**FINAL ENVIRONMENTAL STATEMENT**

**TIJUANA RIVER  
FLOOD CONTROL PROJECT  
SAN DIEGO COUNTY, CALIFORNIA**

**UNITED STATES SECTION  
INTERNATIONAL BOUNDARY AND WATER COMMISSION**

**MAY 1976**

**LOCATION MAP**

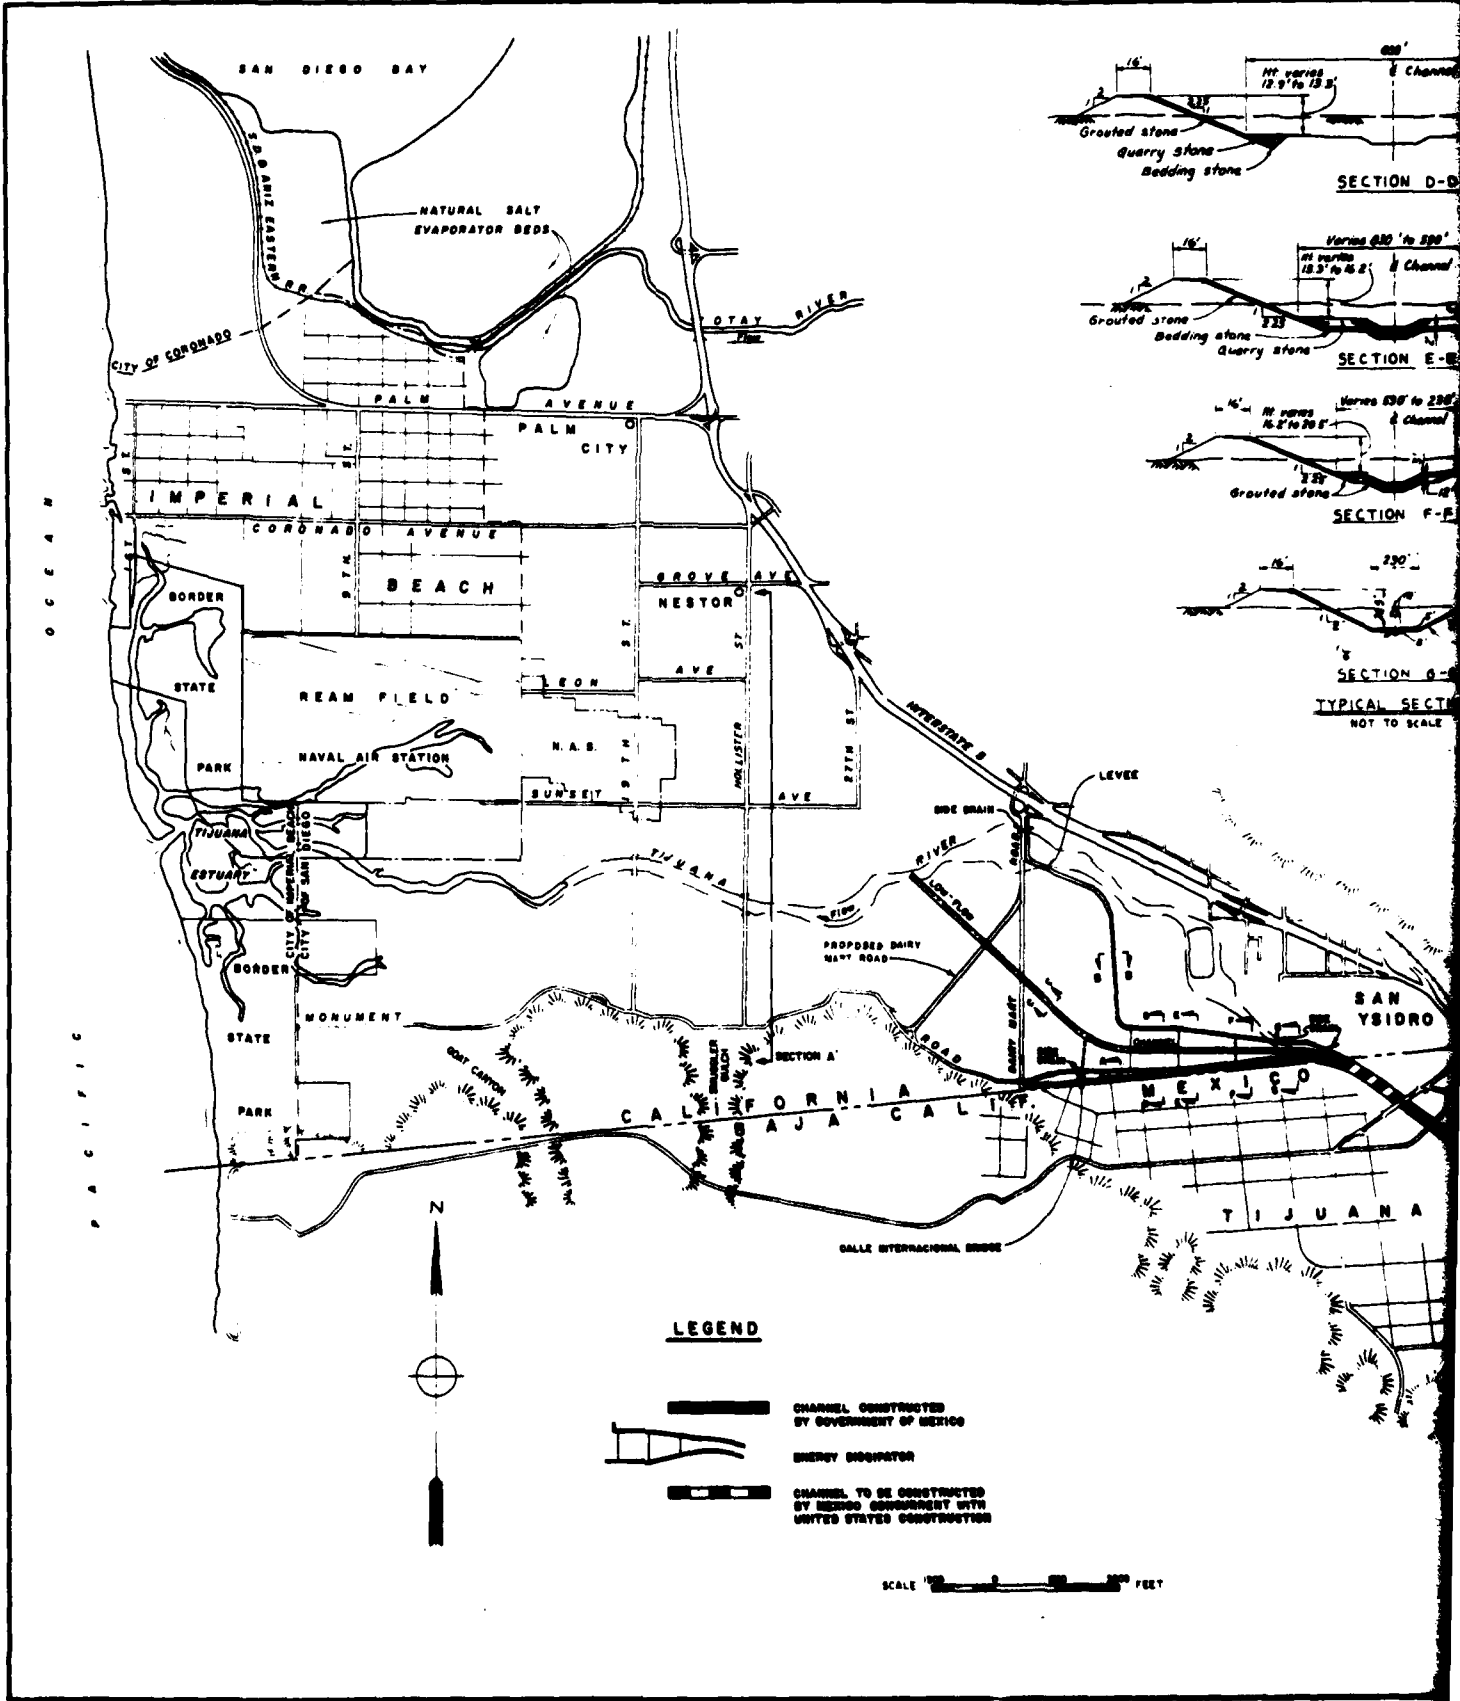
6. Tables 1 and 2 and Plate 1. The location of the two river gage stations and the referenced wells should be shown on the plate for added clarity in understanding the changes in river discharges with distance downstream and variations in the ground water levels relative to the ocean.

**Response:** The project location map (plate 1) has been modified to show a 100-year and standard project flood line in the Tijuana River valley study area. The 100-year flood and standard project flood would inundate about 4,400 and 4,800 acres, respectively. The differences between the overflow lines are imperceptible on the map used in this report.

TYPICAL SECTIONS  
NOT TO SCALE

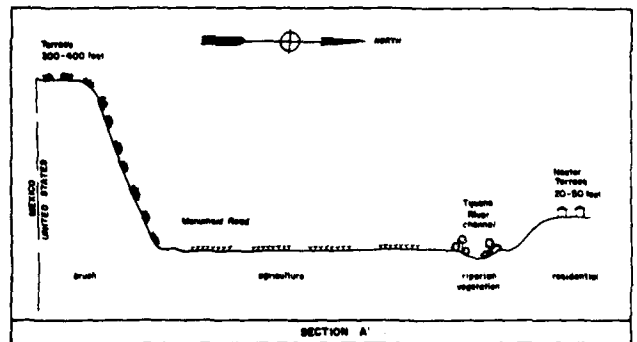
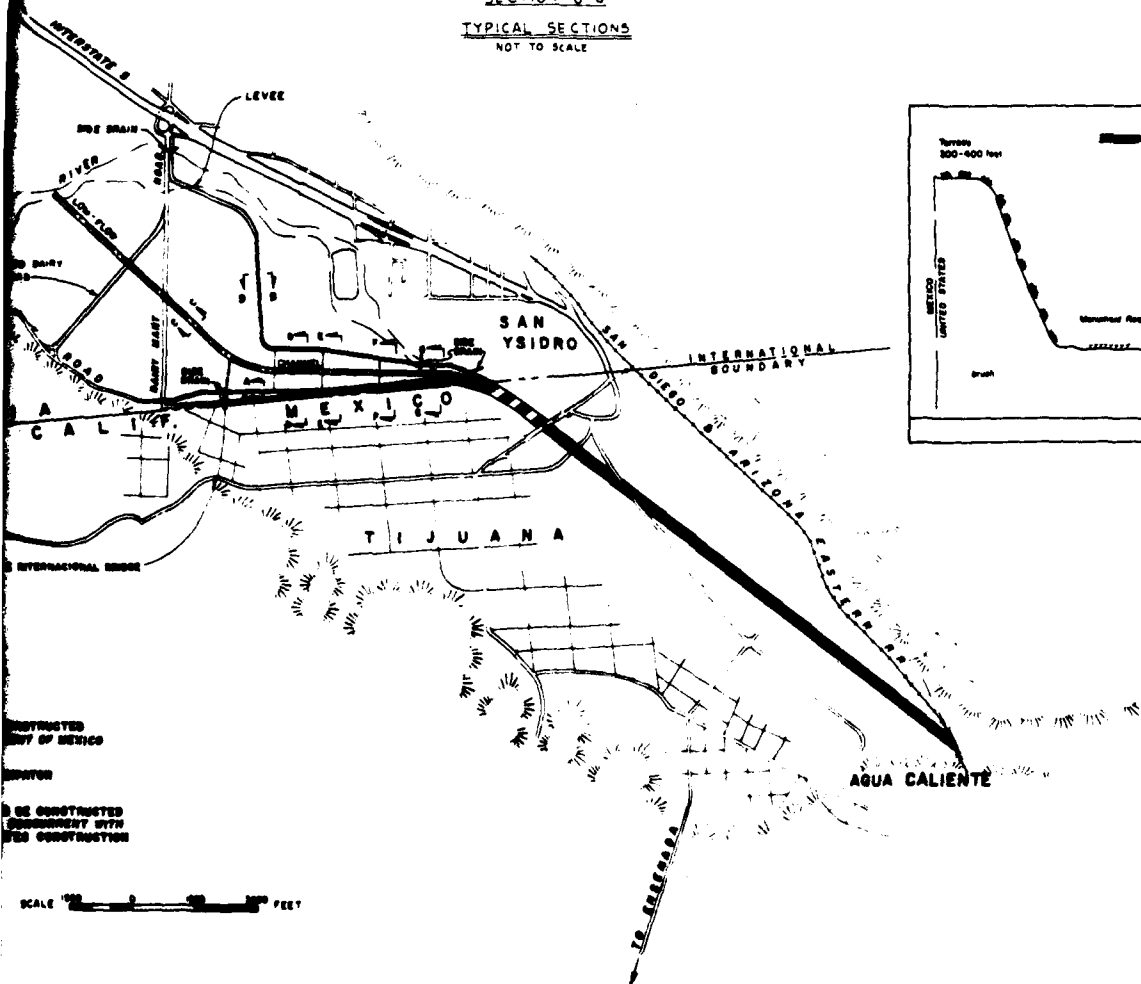
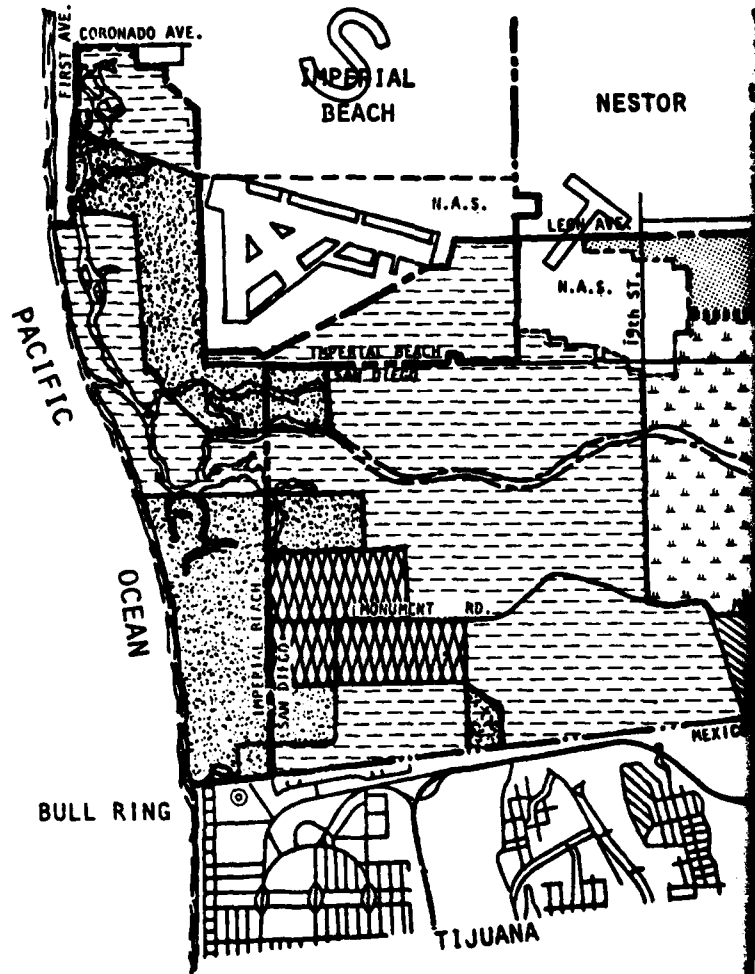
**Comment:** We note that discussion of the levee system is limited to paragraph 7 (c) on page 3 of the Statement and the drawing provided on plate 2. Neither the discussion in paragraph 7 (c) nor the drawings in plate 2 contain sufficient technical data to allow a realistic appraisal of the system's effectiveness by an expert. It is suggested, therefore, that more design detail be included to describe the levee system.

**Comment:** There is an indication in plate 2 that there will be some riprap protection on the side slopes of the levees. Data as to the depth of the riprap is not provided however. (This would appear to be an important factor to an expert who would be evaluating the effectiveness of the plan.)

We note that discussion of the levee system is limited to paragraph 7(c) on page 3 of the Statement and the drawing provided on plate 2. Neither the discussion in paragraph 7(c) nor the drawings in plate 2 contain sufficient technical data to allow a realistic appraisal of the system's effectiveness by an expert. It is suggested, therefore, that more design detail be included to describe the levee system.

INTERNATIONAL BOUNDARY AND WATER COMMISSION  
 UNITED STATES AND MEXICO  
 TIJUANA RIVER FLOOD CONTROL PROJECT  
 TIA JUANA RIVER VALLEY PLAN

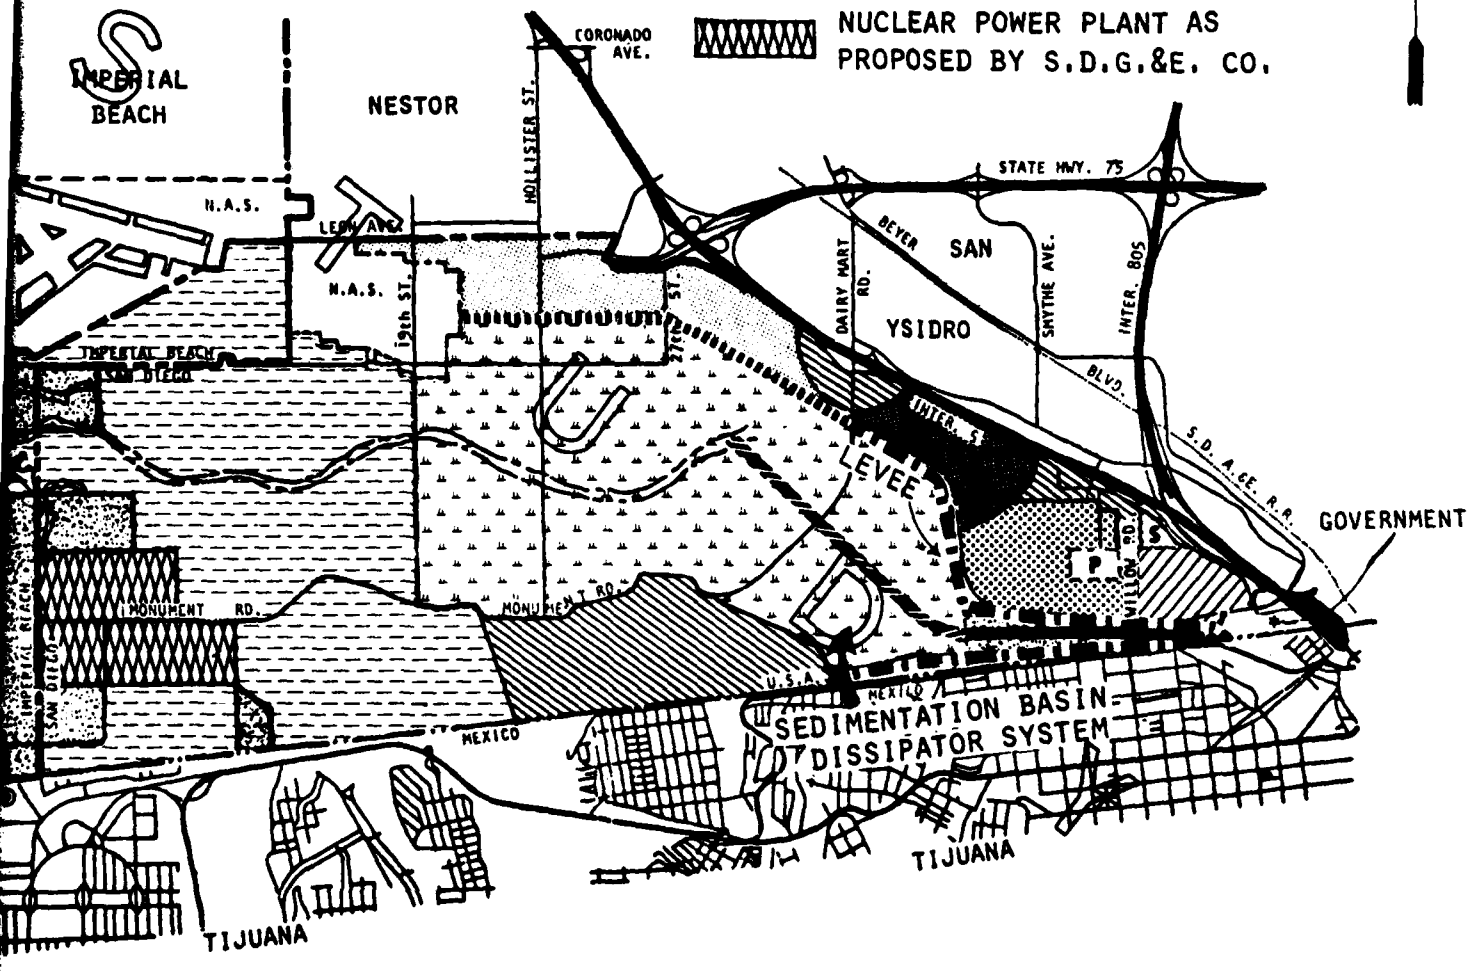
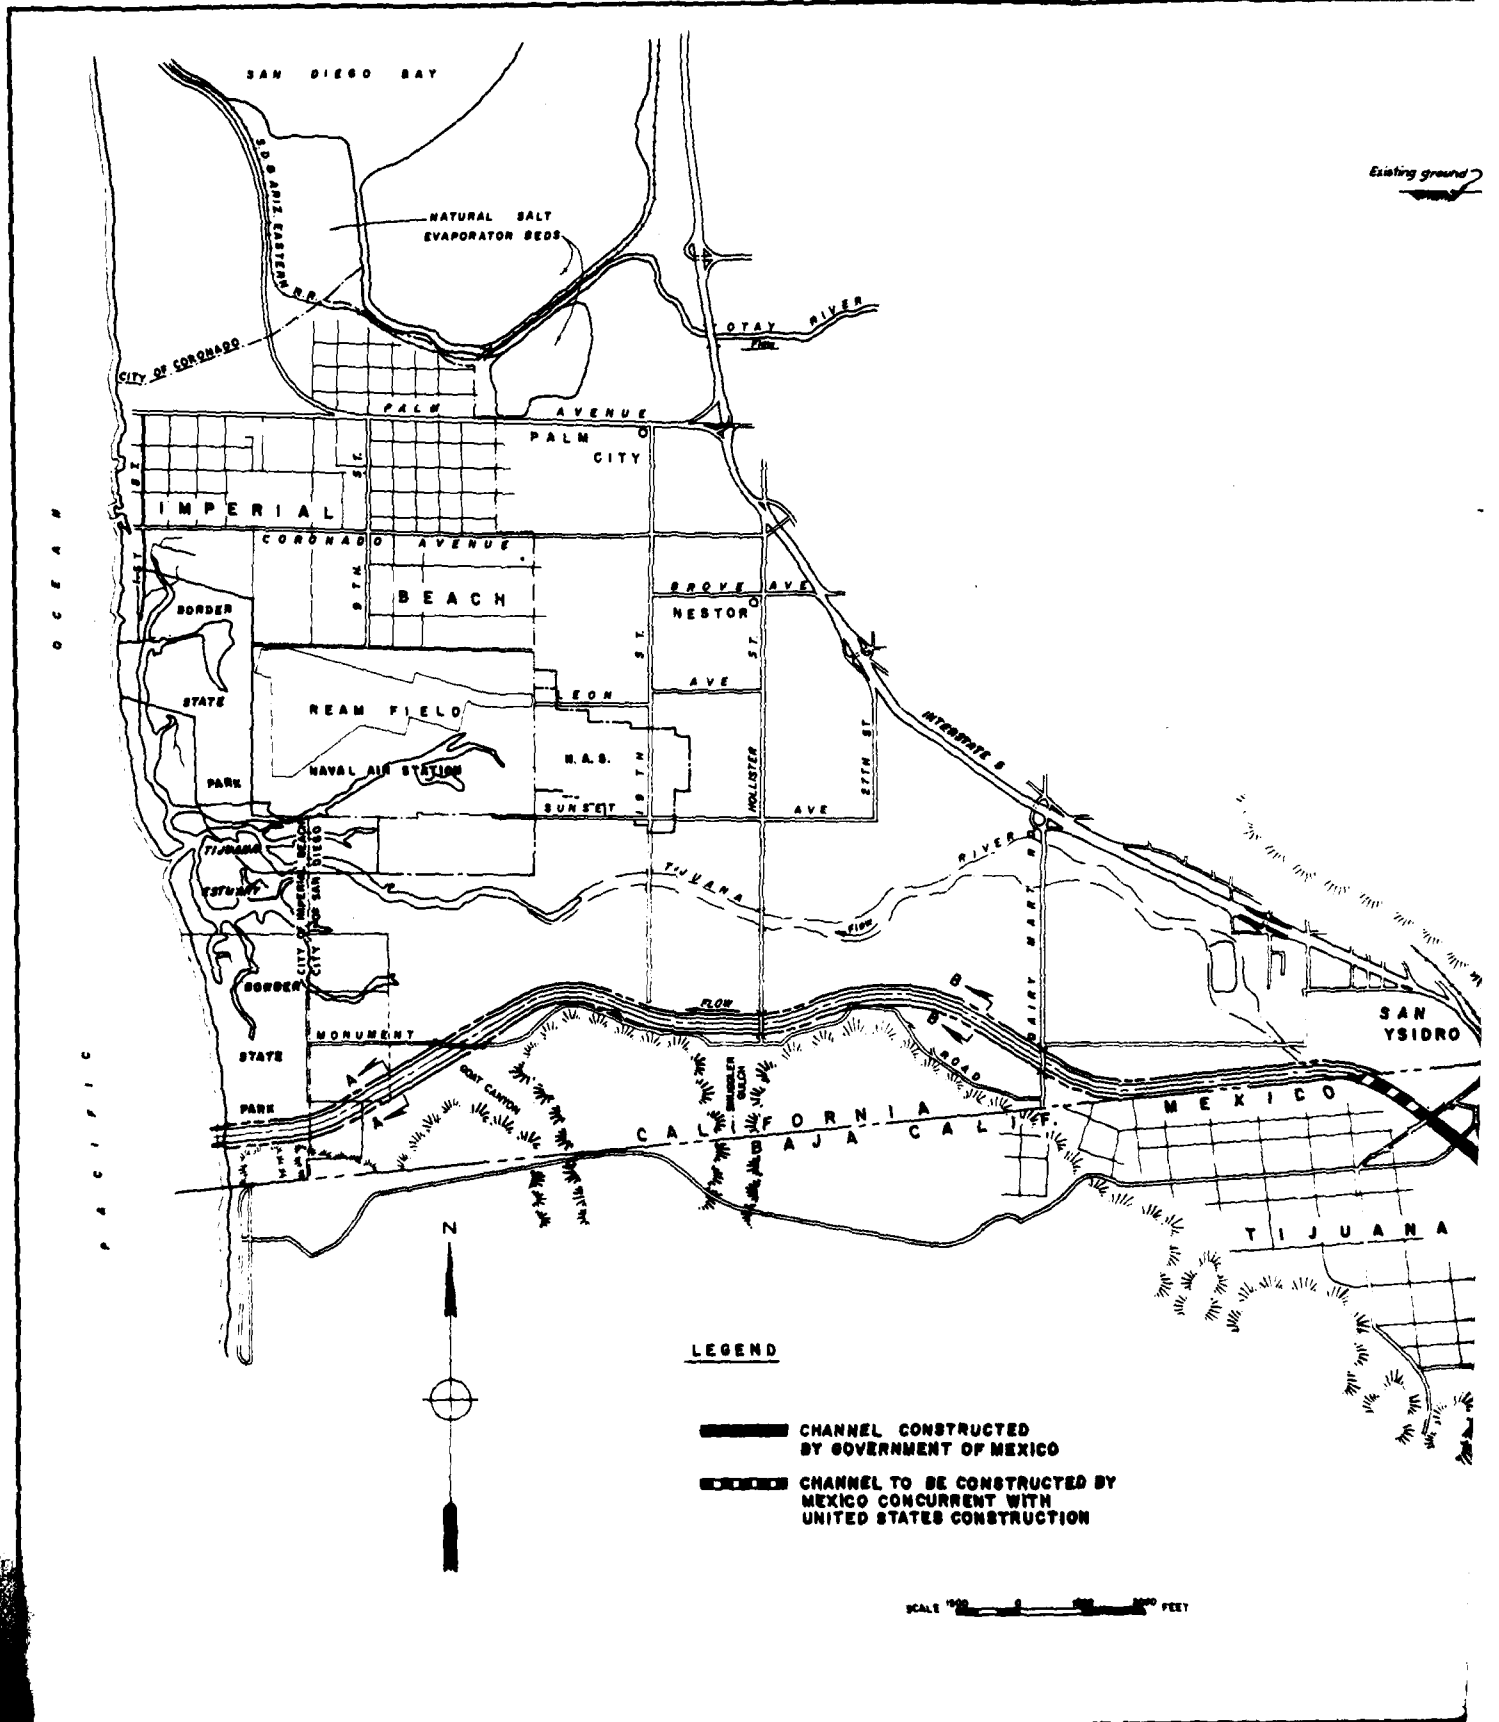
**Comment:** The designation of a neighborhood park and elementary school south of Monument Road on Plate 3 is incorrect and should be deleted.

**Response:** The most recent land use plan proposed by the City of San Diego, as shown in the January 1976 Tijuana River Valley Plan and Environmental Impact Report, is shown in Plate 3.
